BID PACKAGE 02 – ADDENDUM 01**Date:** January 10, 2020**Re:** Wilma P Mankiller Health Center Expansion**From:** James R Childers Architect, Inc.
45 South 4th Street
Fort Smith, Arkansas 72901

CHANGE NARRATIVE LETTER

TO: MATHEW THOMAS- CHILDERS ARCHITECTS
FROM: STEPHEN EDMONDSON, TREY SMITH, BETSY WELLS– HP ENGINEERING, INC.
DATE: 1/10/2020
PROJECT: WPMHC EXPANSION BID PACKAGE 02 ADDENDUM 01

SHEET NUMBER:
E1.14
MECH POWER PLAN LEVEL 01 SECTOR 01

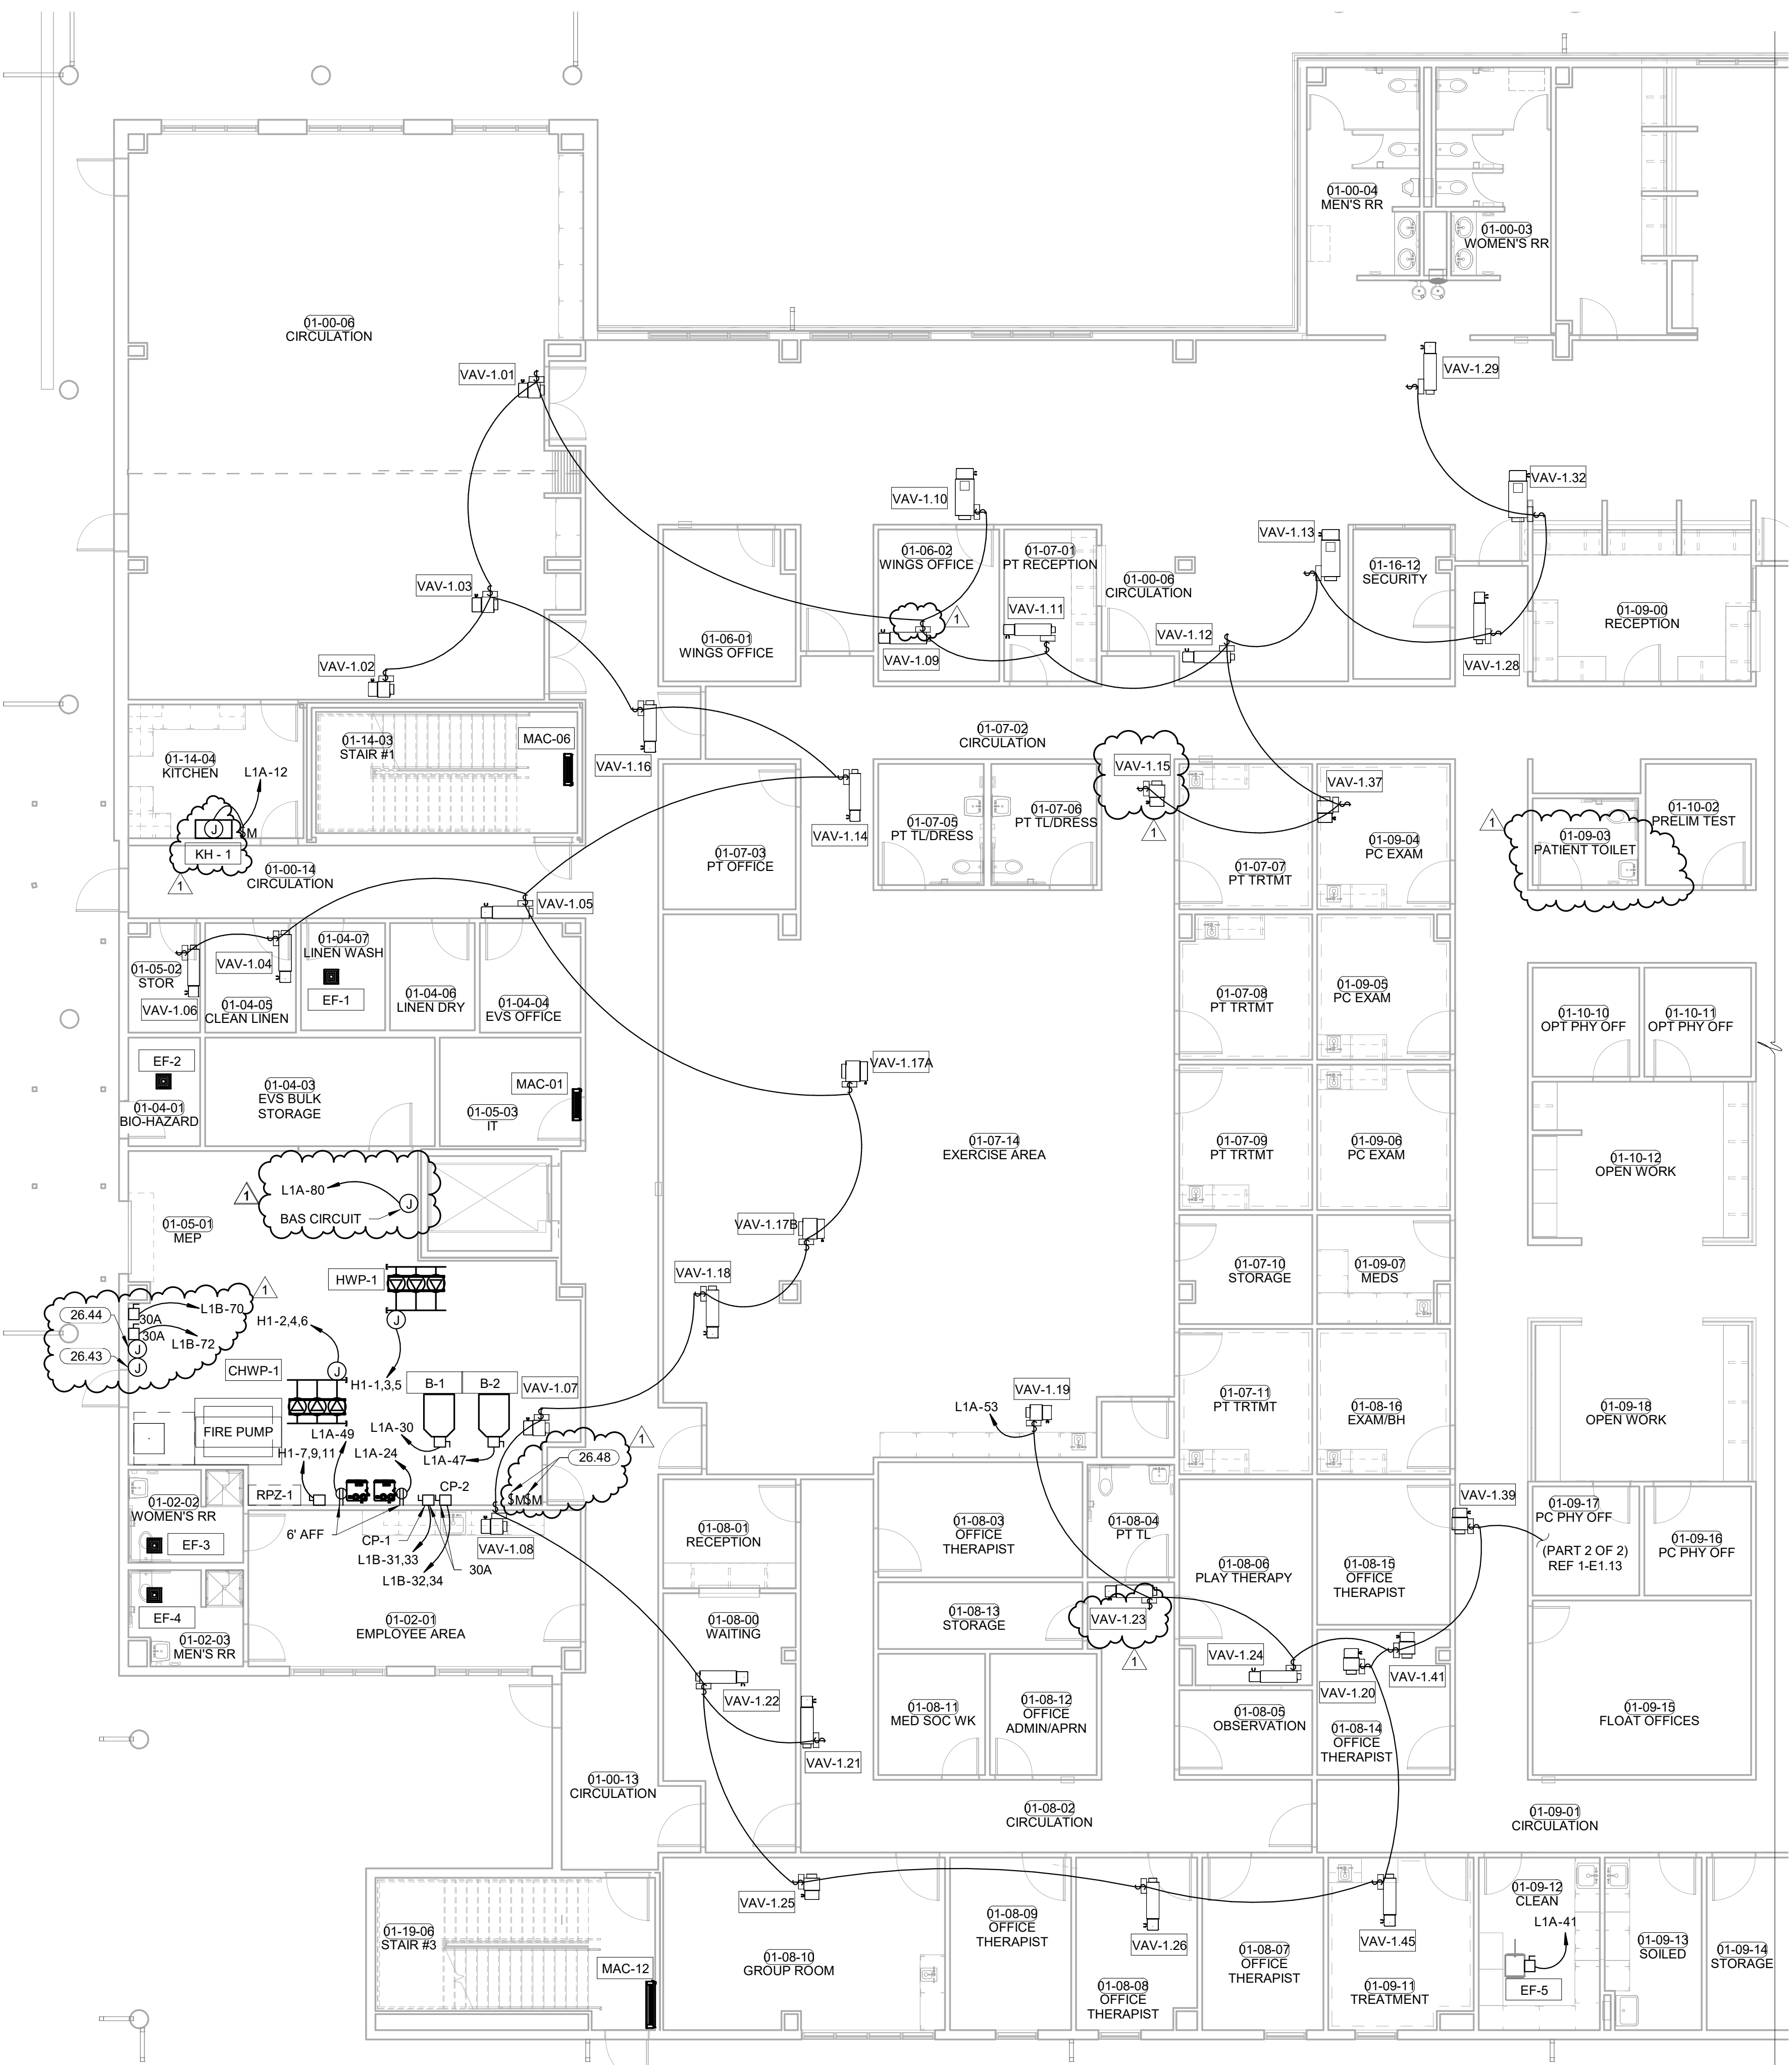
- a. Detail 1 – Revised VAV-1 and VAV-2 circuitry to be isolated from each other.
- b. Detail 1 – Added note for VAV-1 circuitry.
- c. Detail 1 – Added EF-9 location and equipment tag.

SHEET NUMBER:
E2.06

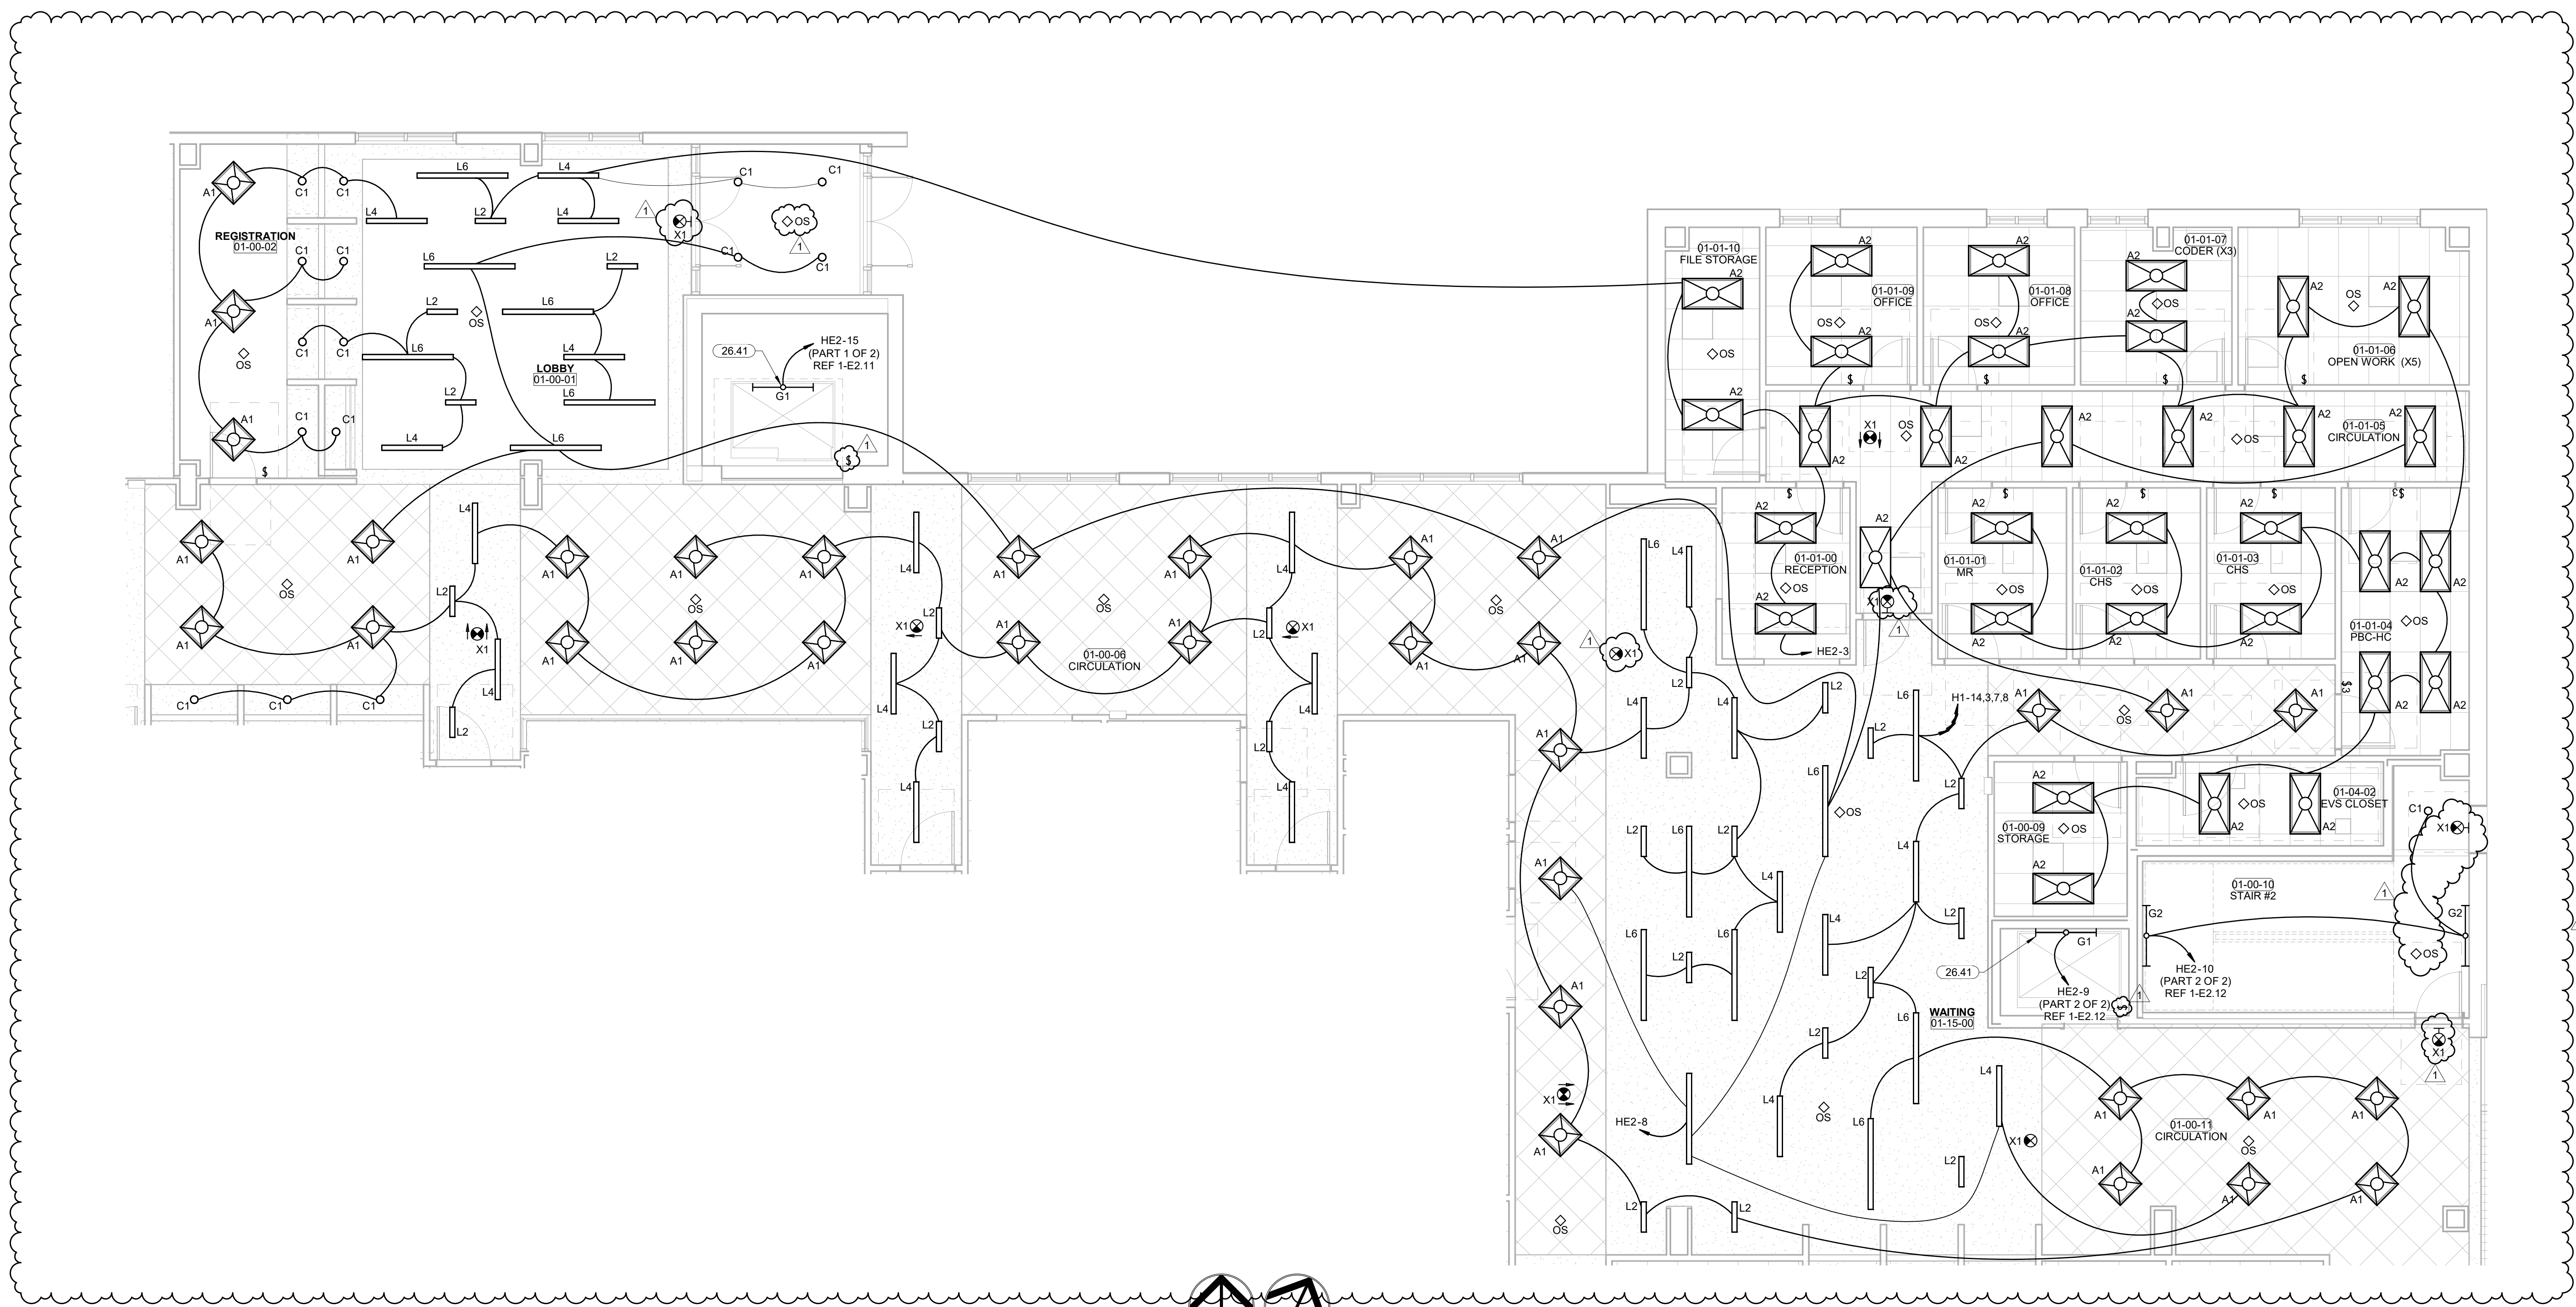
- a. Circuits have been updated.
- 25. E2.05
 - a. Detail 1 – Revised all wires to be shown as dashed.
- 26. E2.06
 - a. Detail 1 – Revised location of ceiling OS in Stair #2 01-00-10.

- b. Detail 1 – Revised location of Type X1 fixture in Stair #2 01-00-01.
 - c. Detail 1 – Added light switch for (2) elevators.
 - d. Detail 1 – Added (1) Type X1 fixture to Circulation 01-00-11.

- e. Detail 1 – Revised location of ceiling OS in Circulation 01-00-11.
 - f. Detail 1 - Added (1) Type X1 fixture to Circulation 01-01-05.
 - g. Detail 1 – Added (1) Type X1 fixture to Circulation 01-00-06.

- h. Detail 1 – Added (1) Type X1 fixture to Lobby 01-00-01.
 - i. Detail 1 – Added (1) ceiling OS to Vestibule.
 - j. Keynotes – Added to sheet.

E2.10
 CENTER SECTOR 2 ENLARGED LIGHTING PLAN

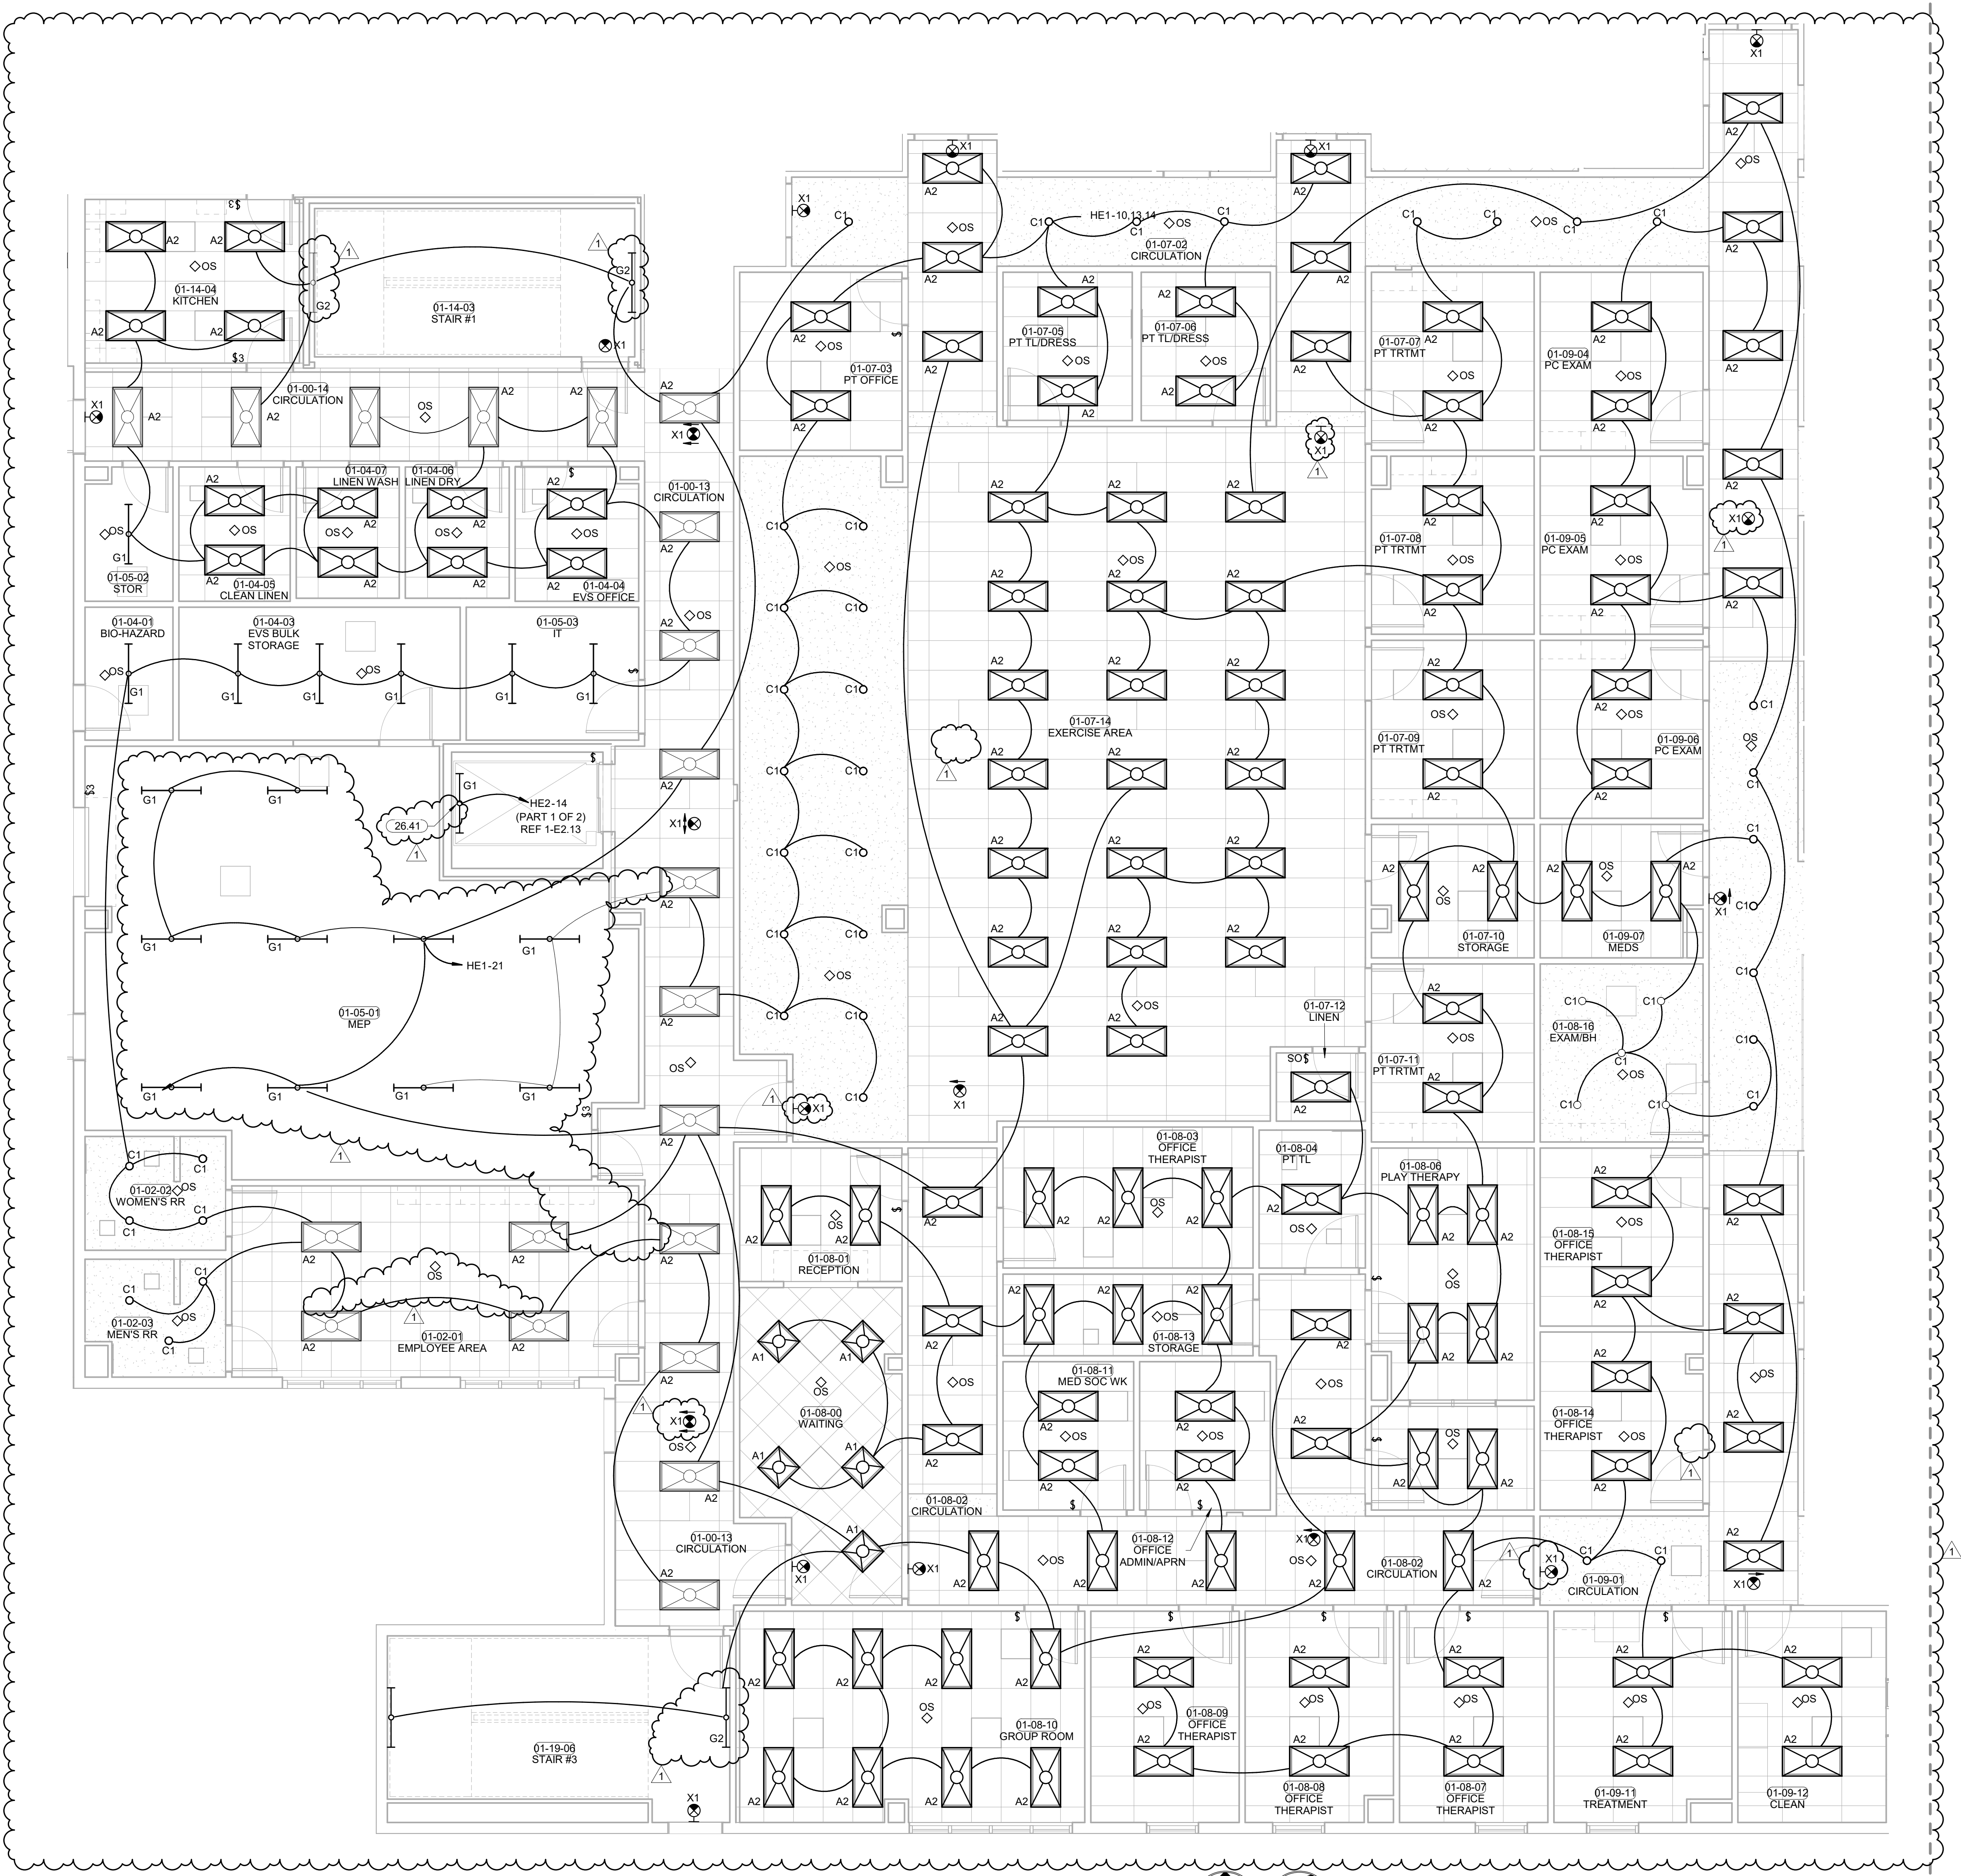
- k. Detail 1 – Revised location of (2) Type C1 fixtures in Women’s RR 01-00-03.
30. E2.10
- a. Detail 1 - Revised (1) Type G1 fixture to be Type G2 in Stair #3 01-19-06.

- b. Detail 1 – Removed (1) ceiling OS from Stair #3 01-19-06.
 - c. Detail 1 – Revised (1) Type X1 fixture two be dual faced in Circulation 01-00-13.
 - d. Detail 1 – Removed (1) ceiling OS from Employee Area 01-02-01.

- e. Detail 1 - Revised location of (1) ceiling OS in Employee Area 01-02-01.
 - f. Detail 1 - Revised circuitry for light fixtures in MEP 01-05-01.
 - g. Detail 1 - Added keynote 26.41 to elevator Type G1 fixture.

- h. Detail 1 – Added (2) Type X1 fixtures to Exercise Area 01-07-14.
 - i. Detail 1 – Removed (1) Type X1 fixture from Exercise Area 01-07-14.
 - j. Detail 1 – Added (1) Type X1 fixture to Circulation 01-09-01.

- k. Detail 1 – Removed switch from Office Therapist 01-08-14.
 - l. Detail 1 – Added (1) Type X1 fixture to Circulation 01-07-02.
 - m. Detail 1 – Revised (2) Type G1 fixtures to be Type G2 in Stair #1 01-14-03.
